PLANNING AND ZONING COMMISSION MEETING AGENDA

August 06, 2025 at 6:30 PM

AGENDA ITEM: Discuss and make a recommendation regarding a Final Plat for a 32.029-acre property situated in the J. Burke Survey, Abstract Number 42, in the Town of Bartonville, Denton County, Texas. The property is located near the southeastern corner of Broome Road and Porter Road, in Bartonville, Texas. The applicant is McAdams, Inc., on behalf of Philip R. and Martha S. Rice. [Town of Bartonville File Number FP-2025-002.]

AGENDA ITEM: Conduct a Public Hearing to hear public comment, discuss, and make a recommendation to the Town Council regarding a Site Plan Amendment for Guidance Preparatory Academy, located at 64 McMakin Road in the Town of Bartonville. The Amendment consists of changes to the landscaping plan for the commercial property. The applicant is Kathryn Taylor. [Town of Bartonville File Number SP-2025-001.]

FINAL PLAT OF THE RICE RANCH ADDITION

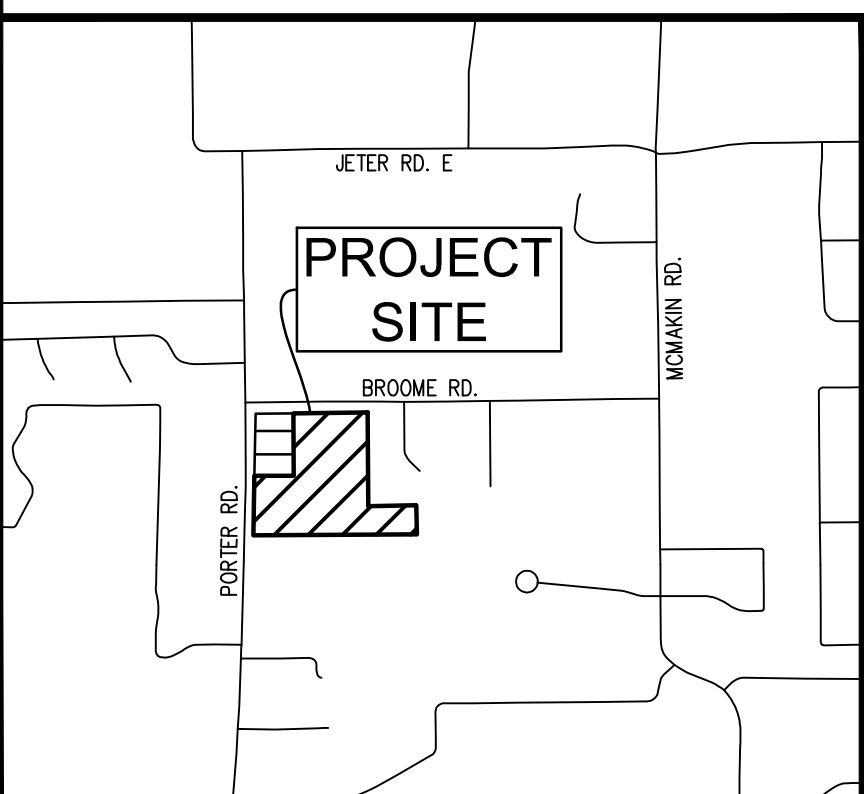
1. Prior to recordation of the final plat, the plat and accompanying planning materials shall be reviewed and approved by the registered sanitarian for the Town of Bartonville, in accordance with Title 30, Texas Administrative Code, Chapter 285, Section 285.4(c).

- a. This condition shall remain.
2. Prior to approval of the final plat, all setbacks for Lots 1R1 and 2R2, Block A shall be 50 feet.
 - a. Addressed.
3. Prior to approval of the final plat, the Broome Road street frontage width for Lot 1R1, Block A shall be increased to no less than 300 feet.

- a. Addressed.
4. Prior to approval of the final plat, the shared lot line between Lots 1R1 and 2R2, Block A shall be adjusted to avoid creation of any nonconformities between existing structures and dimensional standards as they apply to the new lots.

- a. Addressed.
5. Minor correction: The setback label for Lot 8, Block A shall read "50' setback line" or be adjusted to be 20 feet from Lot 2, Block C, Barrington Hills Phase II.

- a. Addressed.
6. Gated driveways shall have the gate or, if present, callbox, located no less than 55 feet from the edge of the Broome Road or Porter Road rights-of-way.

- a. Addressed via final plat per Note 8.

1. Prior to recordation of the final plat, the plat and accompanying planning materials shall be reviewed and approved by the registered sanitarian for the Town of Bartonville, in accordance with Title 30, Texas Administrative Code, Chapter 285, Section 285.4(c). Basis: Town Code Chapter 10, Exhibit A, Development Ordinance Section 2.6.e.4.
2. Prior to recordation of the final plat, the 25' water line easement (WLE) shall be labeled "25' WLE (BY THIS PLAT)". Basis: Town Code Chapter 10, Exhibit A, Development Ordinance Section 3.3.e.

3. Prior to the recordation of the final plat, the "30' GPLE 2010-86118" located within proposed Lot 6, Block A as shown in the approved Rice Ranch Minor Plat (MP-2024-003) shall be shown on the plat, unless documentation of the easement's vacation is provided to the Town. Basis: Scrivener's correction
4. Prior to recordation, the 25' WLE to be established by the plat shall be located to the east of the 30' GPLE along Porter Road. The water and gas line easement cannot overlap in parallel fashion. Basis: Town Code Chapter 10, Exhibit A, Development Ordinance Section 3.3.e.
5. Minor Correction: Note 8 shall read, "Gated driveways shall have the gate, or if present, callbox, located no less than 55 feet from the edge of the road." Basis: Scrivener's correction.

Option 2

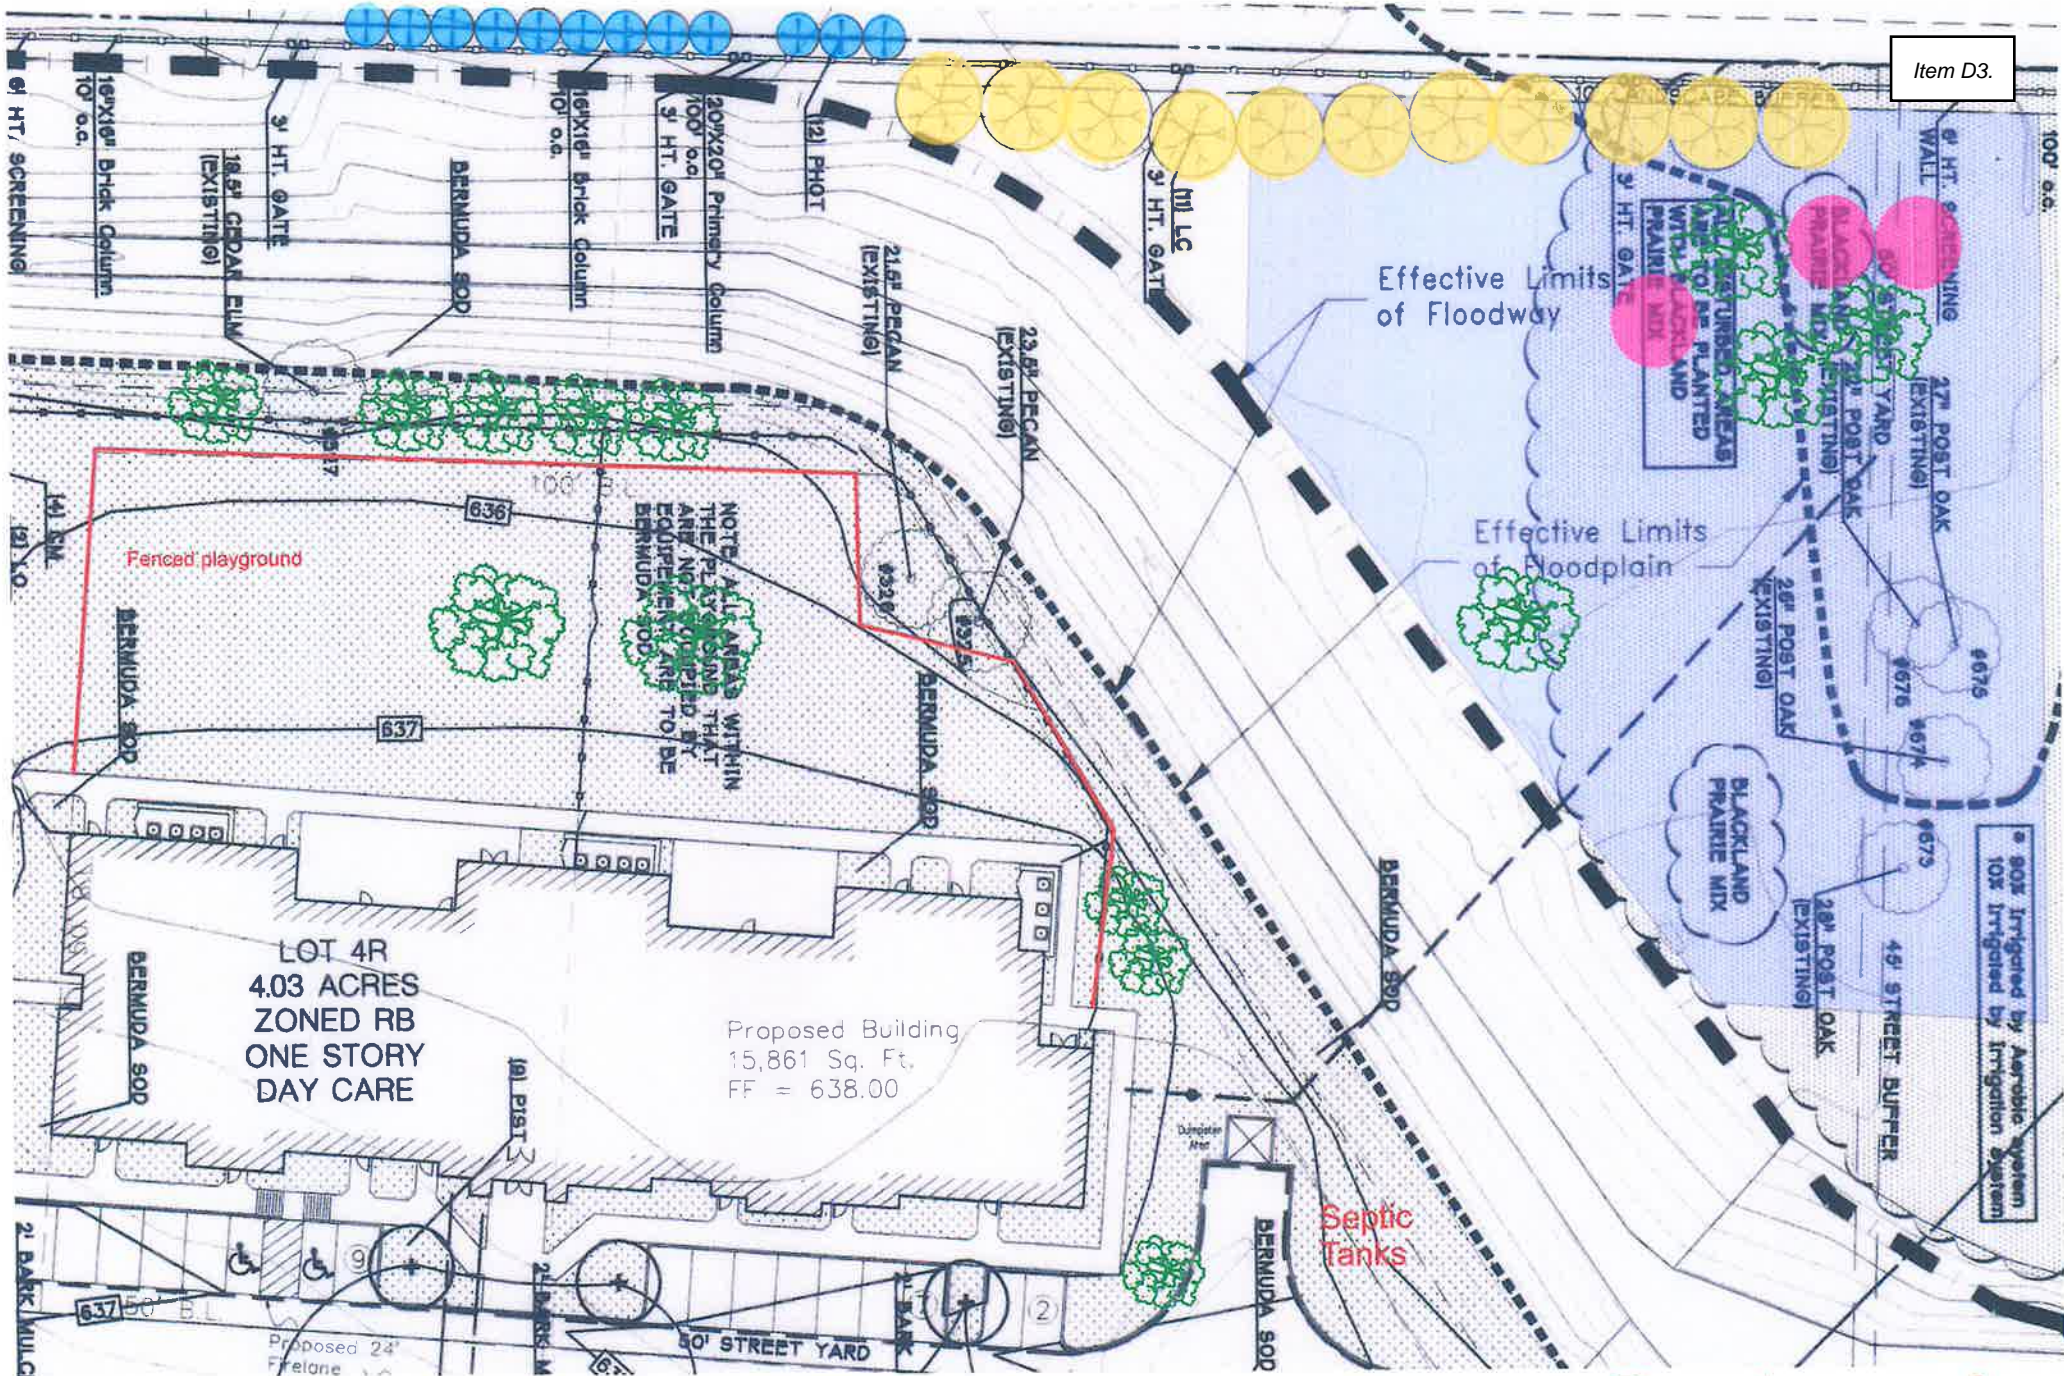
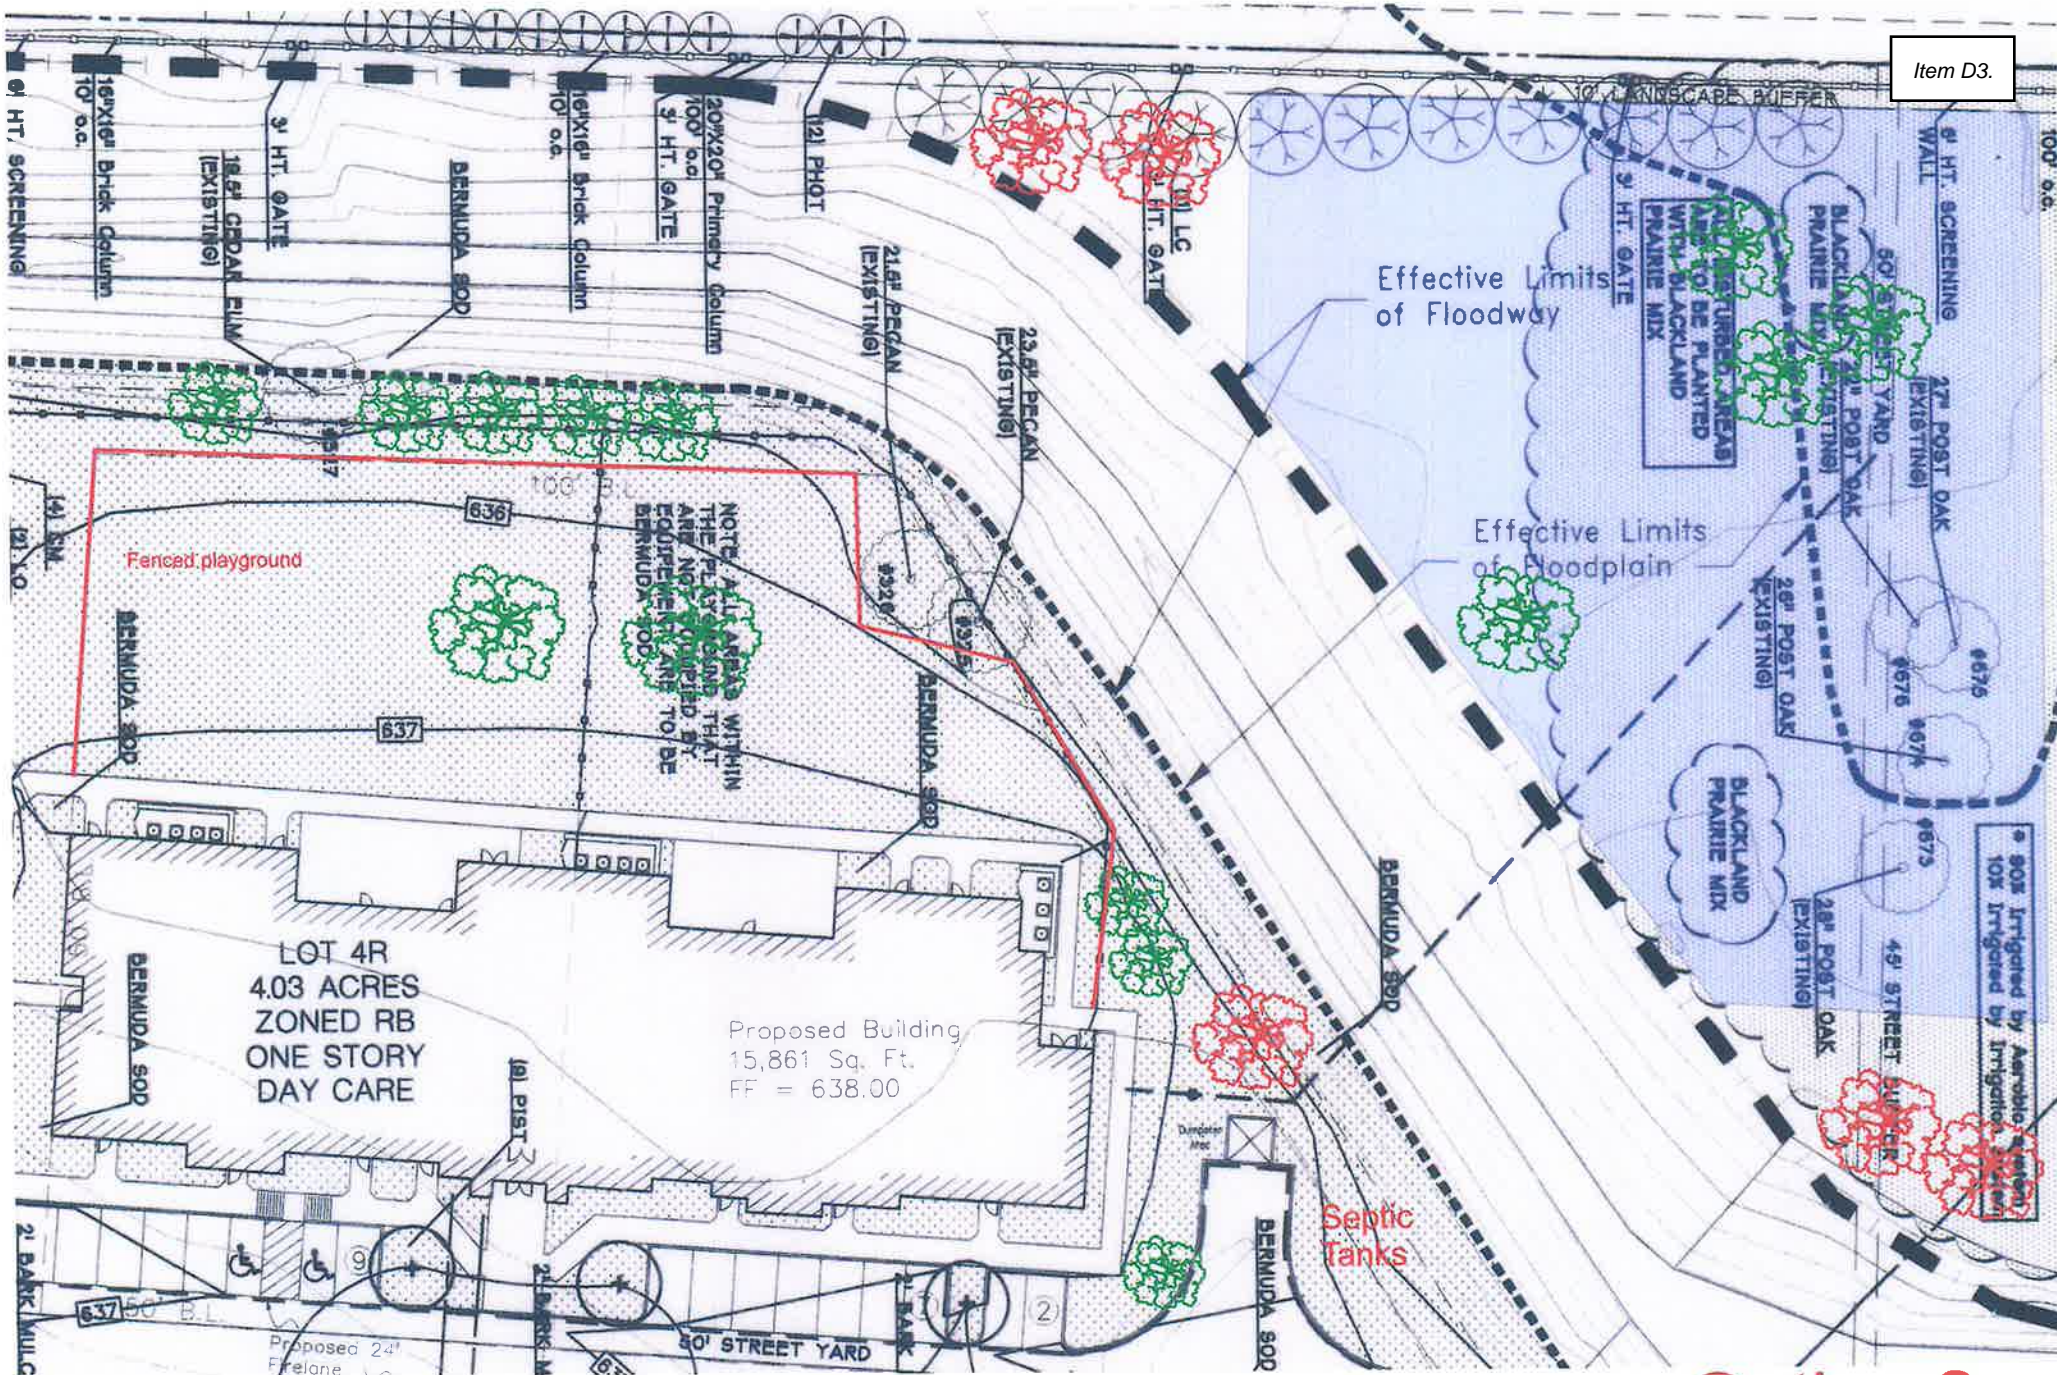
1. The Town would permit the removal of the removed trees from the landscaping plan because the brick wall offers the property delineation and trees planted on the other side of the wall offer the visual barrier. This option would recognize 14 trees already on the property that are not on the original plan but would serve as a replacement.

2. The applicant would plant 5 more oak trees as indicated on the plan included in the attachment. The other conditions in option 1 would remain.
 - a. The landscaping plan would also include the placement of up to 15 boulders to block vehicular access to the site from Post Oak Lane.

Bartonville Development Ordinance (BZO) Section 18.6.k. lists the landscaping requirements for non-vehicular open spaces within the RB zoning district. A total of 25 trees is required for the percentage and acreage of non-vehicular open space on the property. The site is constrained by the regulatory floodway that crosses the property, within which trees cannot be planted due to the need to maintain unobstructed flood capacity. The expanded septic field, stated by the applicant as necessary to provide adequate sewer capacity for the existing 245-student school operation, also limits the available area that can be planted with trees.

The photinia removed from the western side of the screening fence were planted in the location approved by the Town in 2008. However, the planting location was within a recorded utility easement, and subsequent easement maintenance required removal of the trees to gain access to the utility system. Replanting the photinia in this location would not be possible since the utility easement must remain unobstructed. The Leland cypress trees that were lost due to their placement adjacent to the septic system's drain field, according to the applicant, would continue to struggle from that impact should they be replanted in the same location.

Implementation of option 2, with the addition of the requested landscape boulders in option 2.a, represents what appears to be the best option to rectify the tree loss described in the zoning code violation letter, given the constraints on the site. The 21 existing trees identified in the landscaping exhibit (seven existing on the original landscape plan plus 14 identified as added but not on the landscape plan), plus the five additional oak trees represent 26 trees of the 25 required in the code. This would be a reduction from the original approved plan, however, based on review of the original approved site plan, the updated septic system design, and aerial and street view images of the site there don't appear to be any other locations within which to plant canopy trees without conflicting with other infrastructure or known site issues. Recommended conditions of approval listed below are intended to mitigate potential impacts from the planting.

1. No trees shall be planted within the regulatory floodway or public right-of-way.
2. A revised site plan, prepared by a licensed landscape architect, showing the five proposed live oak tree plantings and placement of landscape boulders as indicated in Options 2 and 2.a shall be submitted for staff-level review.
3. New tree planting shall not take place until after October 1, 2025 to ensure best chance for survival.
4. New trees shall be irrigated.
